Updates and clarifications to the residential guidance

If you're using our Residential guidance (Repairing and rebuilding houses affected by the Canterbury earthquakes), you need to also use these updates and clarifications.

Published on 18 June 2018

Issue 10 - June 2018

Figure 1: Extract from Figure 23.32 from Part E of the Guidance

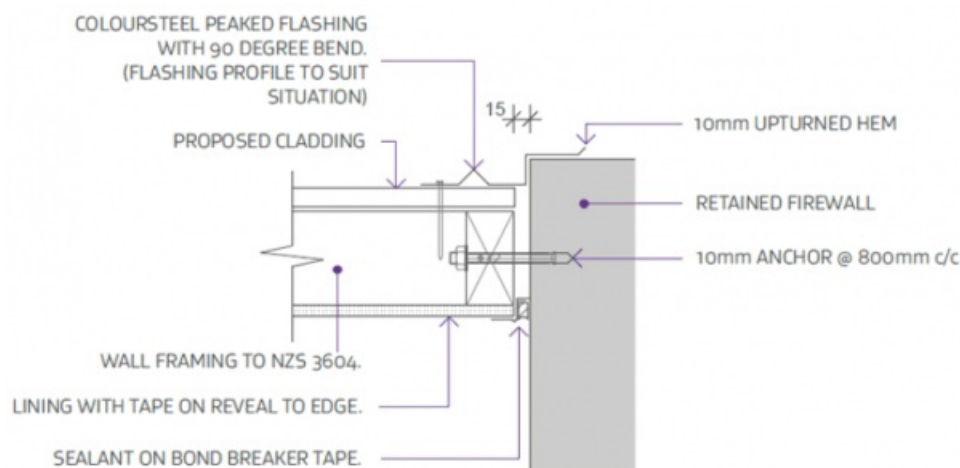
61. What is the required sealant for multi-unit building inter-tenancy walls detailed in Part E (Figures 23.30 and 23.32) of the Residential Guidance?

Sealant is only shown generically in Figures 23.30 and 23.32 (partially reproduced below in Figure 1) to detail the junction of a non-rated (fire and/or acoustic) ceiling or wall to a retained firewall. The new ceiling or side walls in the Figures are not fire or acoustic-rated. Therefore the

sealant does not need to be either fire- or acoustic-rated and any flexible sealant can be used.

Figure 1: Ventilation and drainage requirements when bearers at right angles to the wall when no ventilation is provided in the perimeter foundation.

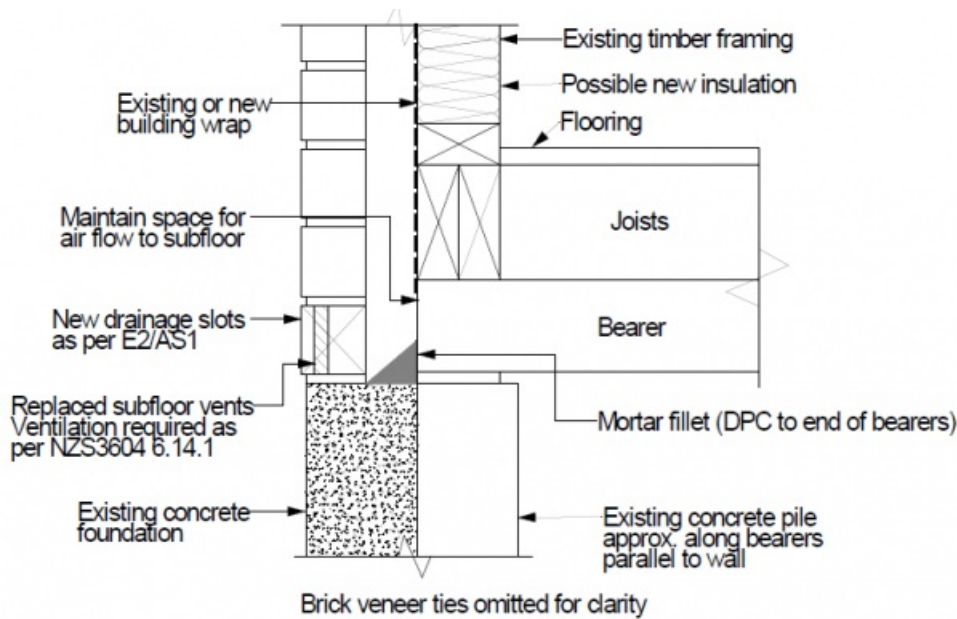
62. Where a brick veneer cladding is being reinstated are there ways of combining the requirement for cavity drainage and sub-floor ventilation when there are no vents in the perimeter foundation?

To illustrate the above, Figures 1 and 2, respectively show cases of bearer at right angles to the perimeter foundation and parallel to the perimeter foundation, and Figure 3 shows options for the top of the veneer cavity.

The veneer cavity ventilation requirements can be achieved by including appropriately sized vents (to E2/AS1, section 9.2.6) in the lower courses of the new veneer and at the top of the veneer. Drainage is provided by leaving the mortar out of vertical perpend of the lowest course (also to E2/AS1) and creating a mortar fillet behind the veneer to force the moisture to flow to the outside.

Subfloor ventilation requirements are different to cavity ventilation requirements and are calculated in accordance with NZS3604 6.14.1. It is unlikely that the slots for cavity ventilation will be sufficient to also provide ventilation to the subfloor space and additional ventilation grills are

required in the lower brick course to achieve the necessary amount of ventilation area.

Figure 1: Steps in the partial removal and replacement of a slab with DPM reinstatement guidance.

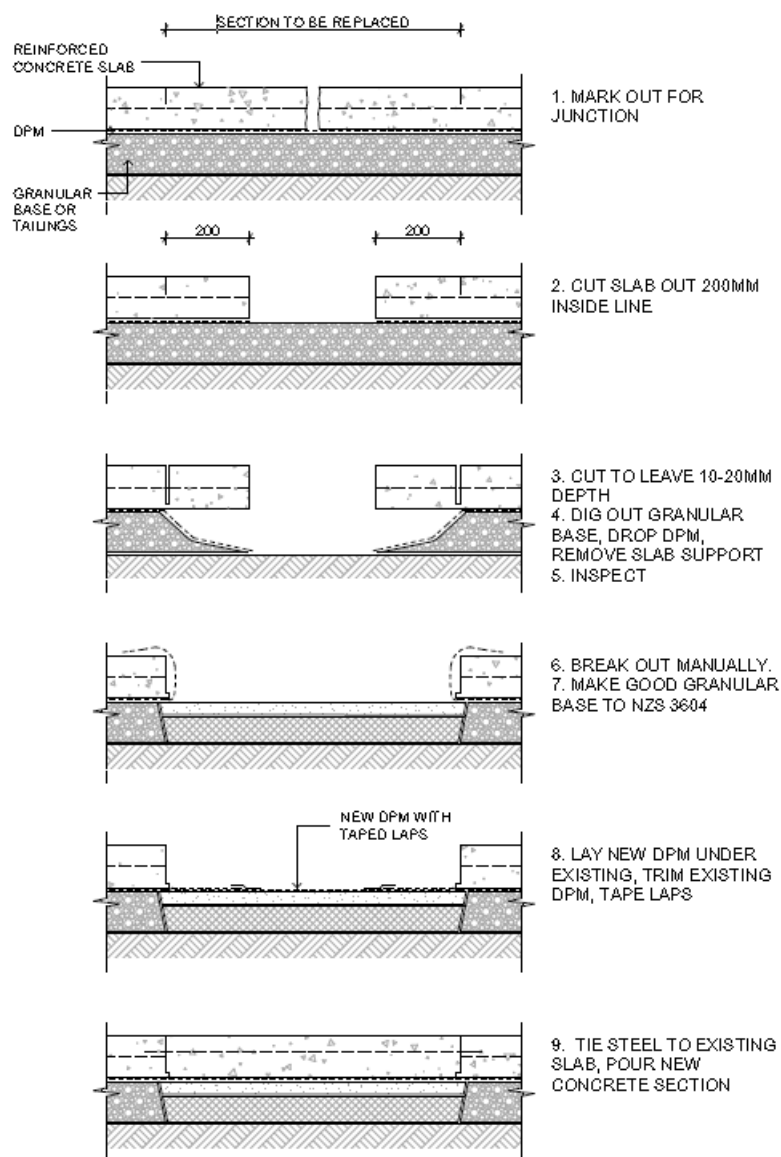
56. The partial replacement of slabs or the raising of slabs by injection through the slab can damage the polythene Damp Proof Membrane (DPM) under the slab. What is required to reinstate the vapour barrier to ensure appropriate moisture control?

At the junctions of replacement slab sections the new piece of polythene DPM must overlap the existing by a minimum of 150mm and be taped in accordance with 7.5.6.1 of NZS3604. Care must be taken during the cutting out process to avoid damage to the DPM beneath a slab. The following process is suggested for taping the new DPM to an undamaged in-place DPM.

Mark out the junction on the slab between the part to be retained and the part to be replaced.

Cut out and remove the slab 200mm inside the replacement line.

Check slab depth and reinforcement location and cut along junction line at a depth of 10-20mm less than measured slab depth making sure all reinforcing is cut.

Excavate granular base or tailings from under cut section to remove support. Drop DPM out of the way.

Inspect exposed base/tailings and ground, and removed base/tailings for evidence of high water table and/or liquefaction material. If the two conditions stated above are satisfied, then proceed; if not, seek specific advice.

Manually and carefully break out slab section, cutting into smaller sections as required, and fold back DPM for access to granular base. This will require careful cutting of the existing DPM diagonally, almost into the corners of the broken out section.

Provide granular base to 7.5.3 of NZS3604 and prepare surface suitable for polythene DPM to 7.5.6.2 of NZS3604.

Lay new DPM and fold down existing DPM. Trim edges to be tidy and straight, suitable for taping, and ensure lap remains a minimum of 150mm. Tape lap to 7.5.6 of NZS3604.

Pour new concrete section to 7.5.8 of NZS3604. reinforcing steel is required in the new slab concrete and must be adequately tied to the retained slab on both sides.

Figure 2.6. Variation in the MSF relationship with q_{c1Ncs} and with $(N_1)_{60cs}$ for cohesionless soils

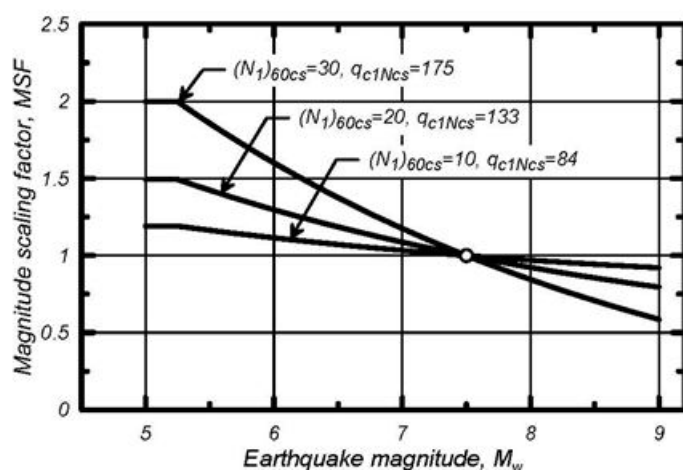
Of these updates to the overall methodology, all but the first one (MSF) presents little difficulty in the adoption of the 2014 analysis method. However the new formulation of the magnitude scaling factor is a significant departure from the methods commonly used to date. The new MSF formulation now not only relates to earthquake magnitude but also varies with the density of the soil (ie q_{c1Ncs} or $(N_1)_{60cs}$ – refer to Figure 2.6 below, taken from UCD/GCM-14/01 “CPT and SPT Based Liquefaction Triggering Procedures” by R Boulanger and I Idriss (2014)).

At $M_{7.5}$ the MSF is still equal to 1.0 for all soils, using the new formulation. However convenient this might at first appear (given that the New Zealand SLS and ULS design accelerations for liquefaction are derived for equivalent $M_{7.5}$ events), for actual events that differ from $M_{7.5}$, the new MSF can vary significantly depending on the density of the soil. For an M_6 event for example, for which the 2008 MSF would be about 1.5, the 2014 MSF will vary from 1.6 for a soil with a q_{c1Ncs} of about 175, to 1.1 for a soil with a q_{c1Ncs} of about 80.

Using the 2008 analysis method, a design event of $M_{7.5}$ and 0.13g will give similar analysis outcomes (in terms of liquefaction triggering and calculated volumetric strain) as design events of M_6 and 0.19g, or M_8 and 0.11g. Using the 2014 formulation however, quite different outcomes can occur depending on the density of the soil. Using the example in the preceding paragraph, a soil which previously was calculated to have a factor of safety (FOS) of 1.0 against liquefaction triggering could now in fact have a FOS that varies from 0.75 to 1.1 for an M_6 event, depending on the density of the soil. Given that volumetric strain occurs up to a FOS of 1.5, the difference in calculated settlement can be significant.

This means that if the 2014 method is adopted, continuing to use the ‘universal’ $M_{7.5}$ design events at SLS and ULS is no longer necessarily appropriate, given the higher probability of occurrence of an event in the order of M_6 in the Canterbury earthquake region. The implications of this in the 2014 methodology are particularly evident for the SLS event, for typical Christchurch conditions. At ULS levels of shaking, the differences are quite muted and therefore it is not considered necessary to carry out a separate M_6 calculation at that level of shaking.

Figure 1: Section elevation; width to height ratio of wall extension

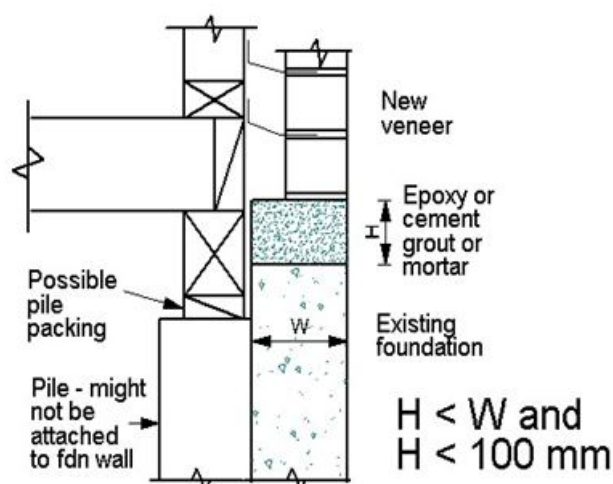
Yes it is acceptable to build up the perimeter foundation of a Type B house to provide a level surface on which to build a new veneer as long as the foundation is still in good condition and does not need to be replaced (refer Table 2.2 or Table 2.3 of the MBIE guidance for re-level/rebuild indication criteria). This will allow the aligning of the veneer with the window sills and the soffits after releveling the floor using jack and pack methods.

- 9 **Limit the ratio of the filler height over the foundation beam width to one, or 100 mm, whichever is the lesser amount.**
Note: If heights are greater than 100mm then specifically designed mechanical fixings should be used.

Case 1: Ends of bearers

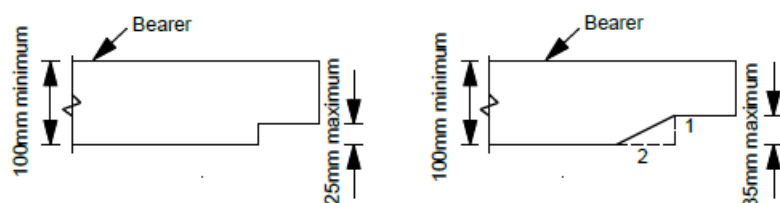
Yes it is acceptable to notch these elements, provided that they are notched within the limits detailed in this answer. It must be done as part of the floor relevening where some jacking and packing is undertaken and the final resulting floor is overall no lower than it was prior to the relevening process commencing. This ensures that Building Act section 112 is complied with in relation to Building Code Clause E1.

The ends of 100mm and 125mm deep bearers may be notched by 20mm with a square cut transition. If the transition is sloped at 2 to 1 then the notch depth may be increased to 35mm. The remaining capacity of the bearer is adequate to take normal design floor loadings of 1.5kPa. On some occasions, engineers have chosen to use a steel shoe adjacent to the notch for added strength.

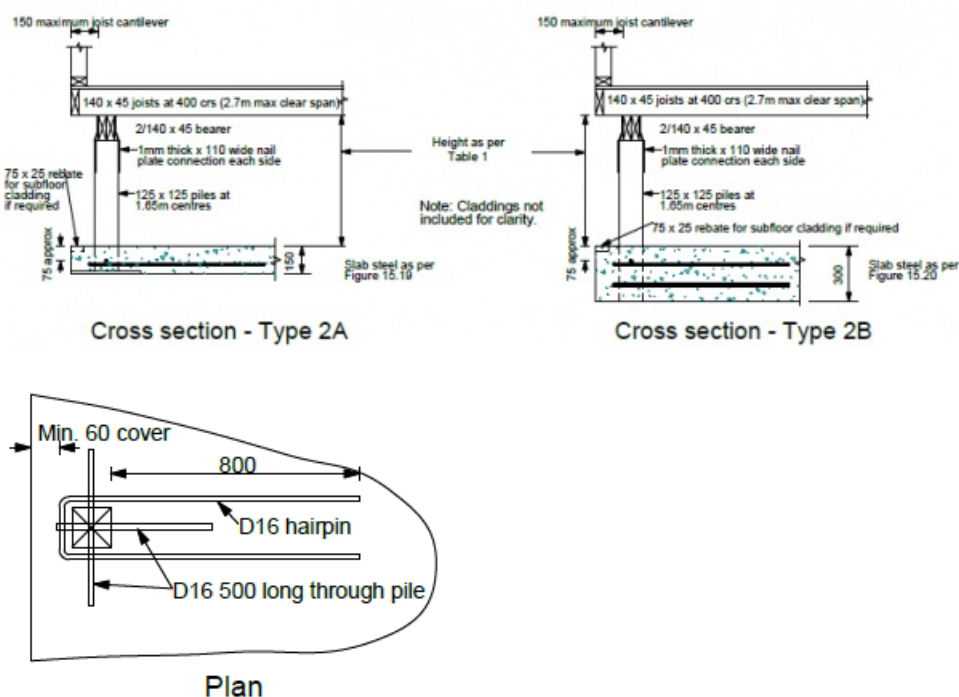
Figures 15.19 to 15.21 of the Guidance indicate that the slab should extend 500mm beyond the exterior row of piles. If the joists and bearers are cantilevered beyond the bearer or the last pile in the row respectively, then it is possible to cover most of the extension. However, it has been determined that a reduction in the joist size to 140 x 45mm and a change in the bearer size to 2/140 x 45mm members is a more economic option for these structures. This means that the span (a maximum 2.7m clear span when at 400mm centres) is less than a 190 x 45mm joist can span and extra rows of piles will be required. It also means that the overhang of the joist on the bearer (the cantilever) may only be 150mm. This is suitable for both single and two storey houses with light roofs and either light or medium weight wall cladding.

The new details for the Type 2A and Type 2B under-slab in TC3 have been developed as shown in the following figures. These details should be read in conjunction with Figures 15.19 to 15.21 of the Guidance.

Figure 1: TC3 Type 2A-150 Foundation

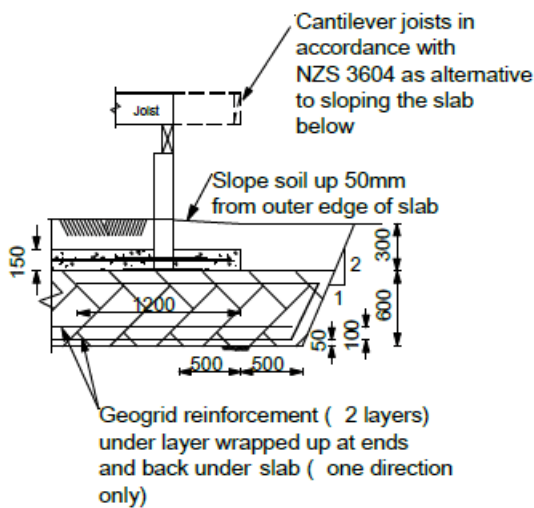
46. There have been some changes to the descriptions of the TC3 Type 2 surface structure foundations in the Guidance. Can you please provide a summary of the available Types and their specifications?

Identifier	Description	Maximum calculated SLS settlement (mm)
(refer to Figure 1)	A 150mm concrete under-slab in combination with a 600mm reinforced gravel layer (refer to Figure 15.19)	100mm
(refer to Figure 2)	A 300mm concrete under-slab, reinforced as per type 2b slab over a 150mm layer of compacted well graded sandy gravels extending 500mm beyond the edge of the slab and with a geotextile layer under the compacted gravel. The geotextile layer is to be turned up at the ends of the gravel layer and returned a minimum of 1m under the slab.	100mm
(refer to Figure 3)	A 300mm concrete under-slab in combination with a 600mm reinforced gravel layer (refer to Figure 15.20)	200mm
